SERVICE LETTER

No. 667A

Piper Aircraft Corporation

Stabilator Attachment Bolts

Stabilator Attachment Hardware

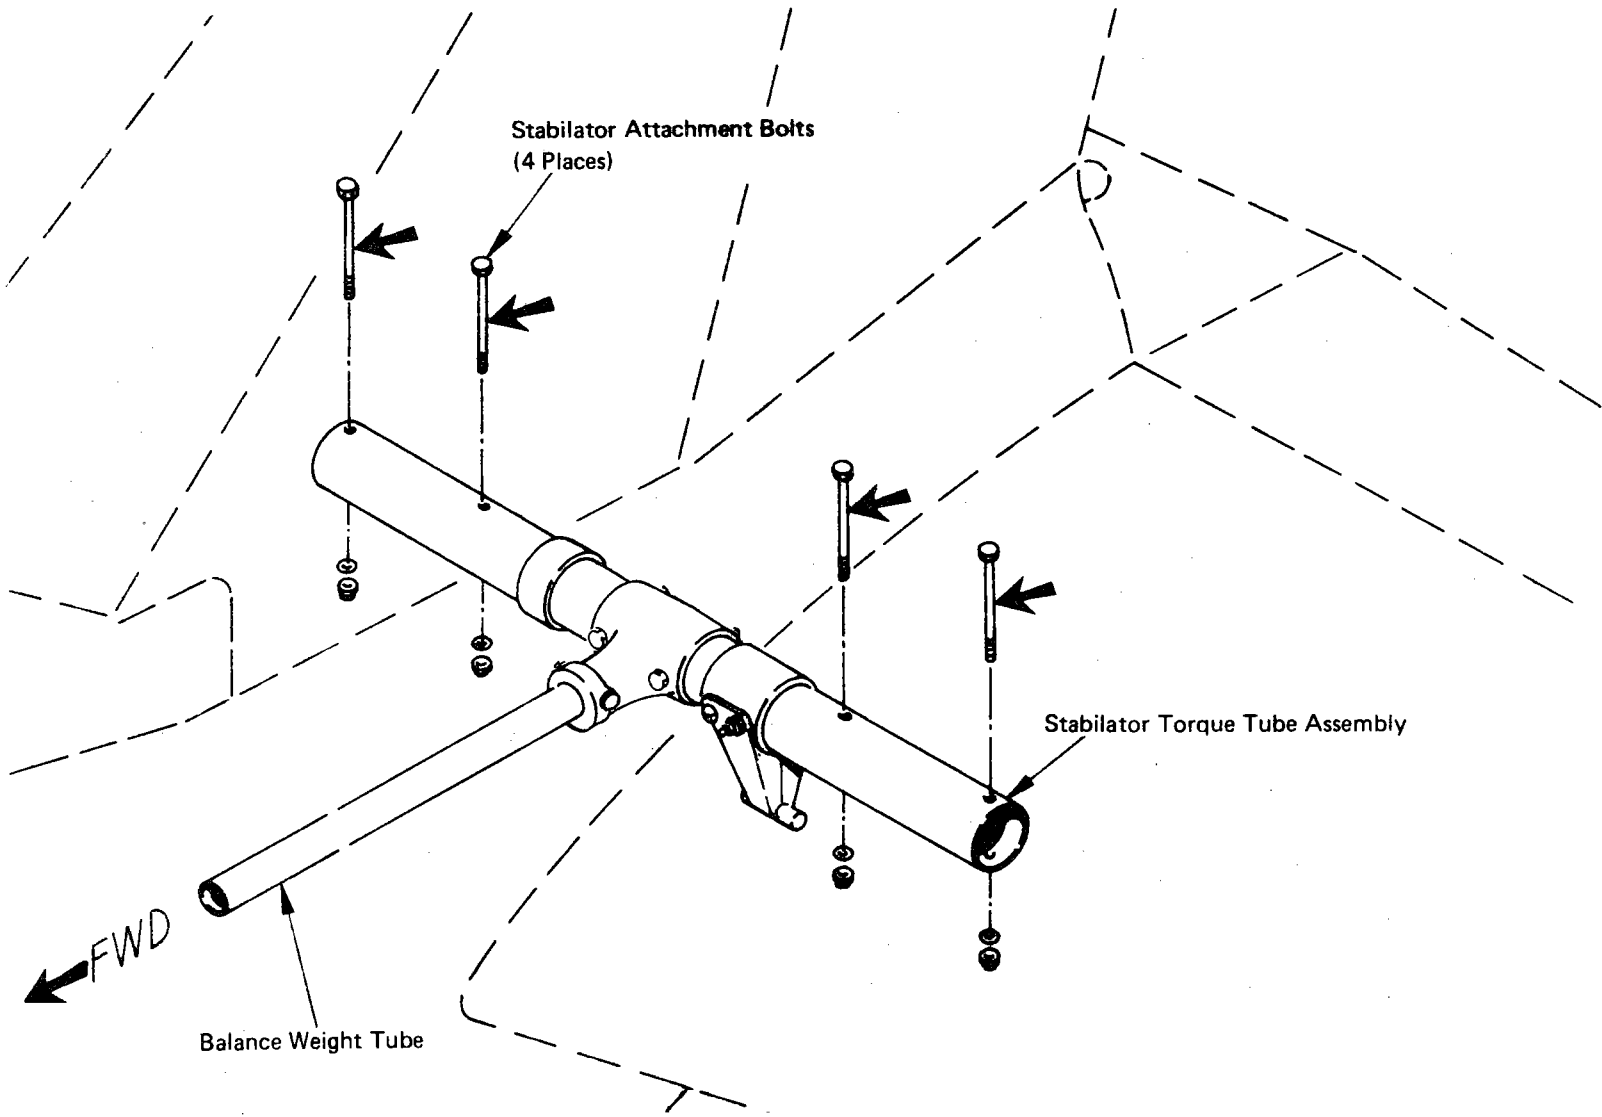
Remove existing stabilator attachment bolts, washers and nuts, indicated on sketch, and install new bolts and attaching hardware. **CAUTION:** Remove and replace one bolt at a time. Refer to sketch for correct replacement hardware identification and proper assembly of bolts, washers and nuts.

2. Correct torque value for bolts is as follows:

- a. PA-24-180/250 and 260 - torque to 30-40 inch lbs.
- b. PA-23-235/250/250 (Six Place) and PA-24-400 - torque to 60-85 inch lbs.
- c. PA-30 - Refer to the Twin Comanche Service Manual (Section 4 - paragraph 49) which states that the nuts ("holding the stabilator to the torque tube") should "be tightened just enough to take the play out of the washers."

- Bolt AN174-C32A P/N 502 329 (Corrosion Resistant) or Bolt AN174-32A P/N 402 329 (Non-Corrosion Resistant)
- Washer AN960-416L P/N 407 585
- Nut MS20365-428C P/N 404 888

- Bolt AN175-C32A P/N 502 342 (Corrosion Resistant) or Bolt AN175-32A P/N 402 342 (Non-Corrosion Resistant)
- Washer AN960-516 P/N 407 566 (PA-23-235/250 and 250 Six Place only)
- Washer AN960-516L P/N 407 586 (PA-24-400 and PA-30 only)
- Nut MS20365-524C P/N 404 889
